SC&A RESPONSE TO NIOSH WHITE PAPER FOR GSI APPENDIX BB REVIEW

Prepared by

Robert Anigstein
S. Cohen & Associates
November 8, 2008

Figure 1. Normal Score Plot of Average Weekly Doses to Individuals

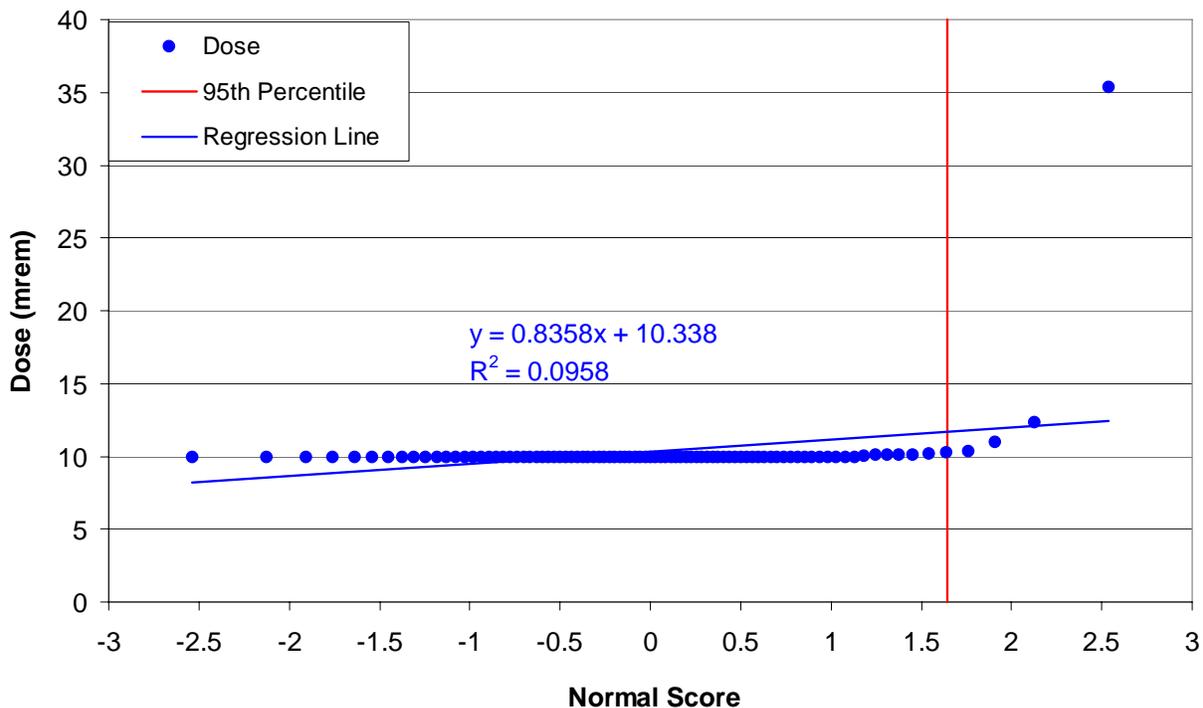
To determine the goodness of fit of the data to a normal distribution, we constructed a normal score plot of the average weekly doses to the 89 individuals, as calculated by NIOSH. This plot is shown in Figure 1. The horizontal axis in this figure is the normal score or z-score, which measures the number of standard deviations the value is from the center of the distribution. The assigned values form a horizontal line at 10 mrem. The regression line fits closely to these values, due to the large leverage of values on the left side of the figure. The extreme high value on the right lies far from the regression line in this case. The red vertical line marks the location of the 95th percentile.

The R^2 for this regression is 0.096, indicating that the normal distribution provides a very poor fit to the distribution of values. In this case, a large majority of the data points lie close to the regression line, but the normal distribution provides a poor fit to the values in the upper tail of the distribution.

Figure 2. Lognormal Score Plot of Average Weekly Doses to Individuals

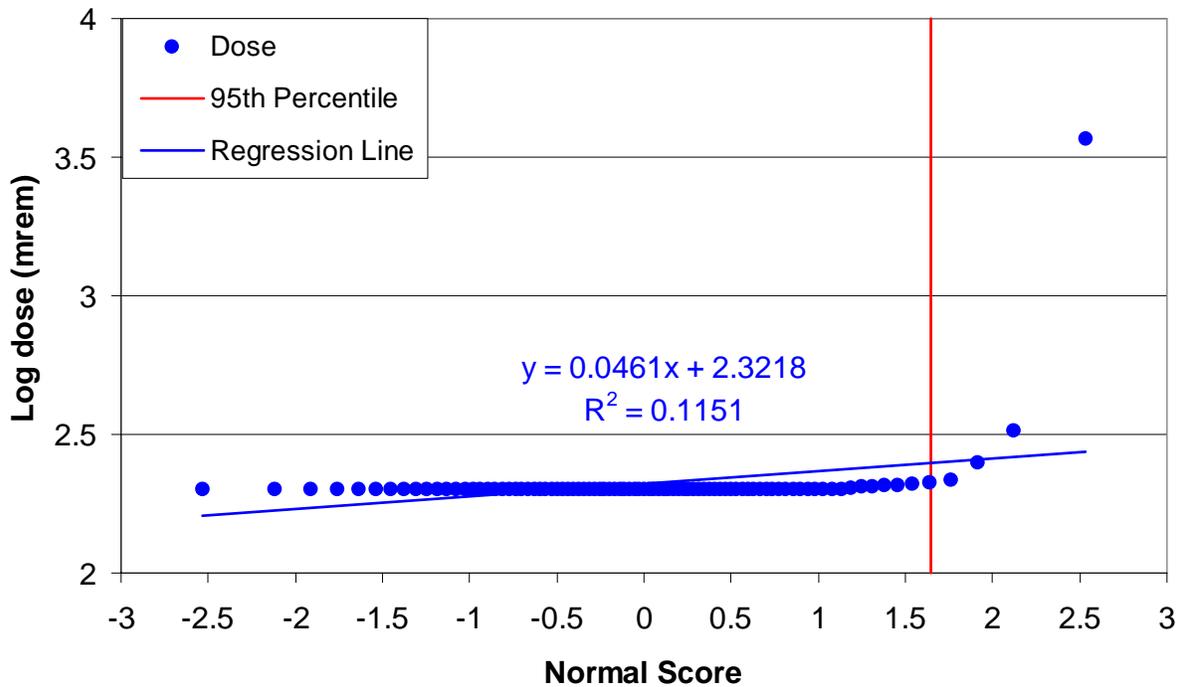
We next tried to fit a lognormal distribution to the same data, as shown in Figure 2. The R^2 for this regression is 0.115, which indicates that the lognormal distribution is a slightly better fit than the normal. However, neither fit satisfy the criterion specified by Brackett (2005) in OTIB-0019: “A value [of R^2] greater than 0.9 indicates a very good fit; however, values as low as 0.7 are acceptable, and even lower values may be acceptable if no better equation seems appropriate.” Values of 0.096 or 0.115 are completely outside the acceptable range. This is despite the fact

that a rank-ordered data, such as those used to construct these plots, yield an R^2 with an inherent upward bias. Consequently, neither an assumed normal nor a lognormal distribution appear to constitute a scientifically valid basis for assigning doses to GSI workers.
